PROJECT NAME: 412 6th Street
Roseville, CA 95678

ASSIGNMENT: Evaluation of design and its impact on existing trees

PLAN EVAL DATE: March 13, 2025

REPORT DATE: April 7, 2025

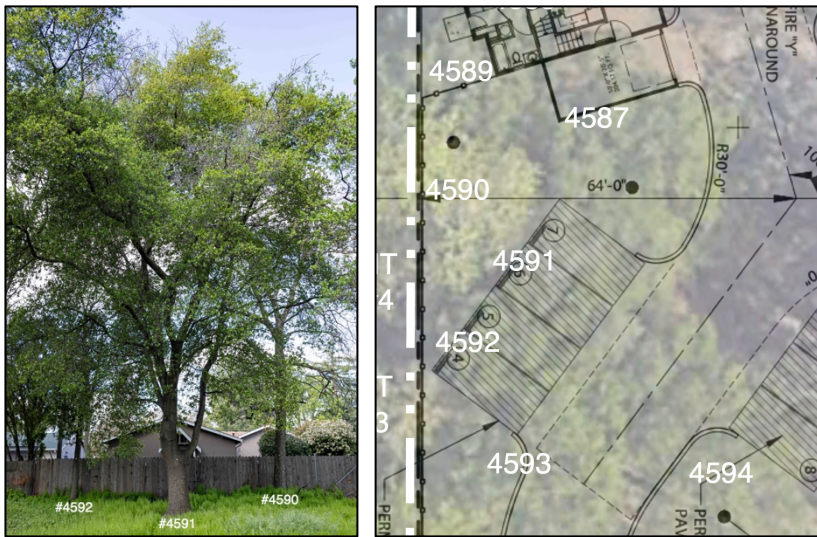
There are 2 trees next to the western property line, #4596, a camphor and #4595, a valley oak (photos at right) that are codominant where the valley oak depends on the camphor. Retaining the camphor will require specific pruning treatments for clearance. Camphor trees have a low tolerance for root damage so specialized excavation and root

pruning will be required. Root pruning requirements will not be known until they are excavated. In the event the camphor will not tolerate the required root pruning removal would be the option.

The canopy of the camphor has been shading the trunk of the valley oak which is now dependent on that shade. Removal of the camphor tree will expose the trunk of the valley oak to sunscald. Sunscald occurs when bark that is usually shaded by foliage becomes fully exposed to sunlight. The excessive sunlight causes the tissue in the bark to become so hot that the cells in the cambium start to die. This results in dried out bark that flakes off creating lesions in the bark that over time open up into large wounds. The damaged area then becomes a decay pocket that is sometimes not recognized. These types of wounds can go undetected but will eventually weaken the stem of the valley oak which could lead to its failure or ultimate decline.

Removing the camphor would also leave the remaining valley oak with a low live crown ratio. The live crown ratio (LCR) is the ratio of crown length to total tree height. The LCR is affected by species, growing conditions, pruning history, previous branch failures, and natural branch shedding. A low LCR is created when the crowns are over-pruned. In this case a low LCR would be created with the removal of the camphor. A low LCR is a condition of concern, especially when the tree is exposed to higher wind conditions that follow soil saturating rainfall. A general rule for urban trees is when the LCR is less than 30% there is an increased likelihood of whole tree failure when taking in to account site-specific factors such as construction and excavation that could contribute to tree instability.
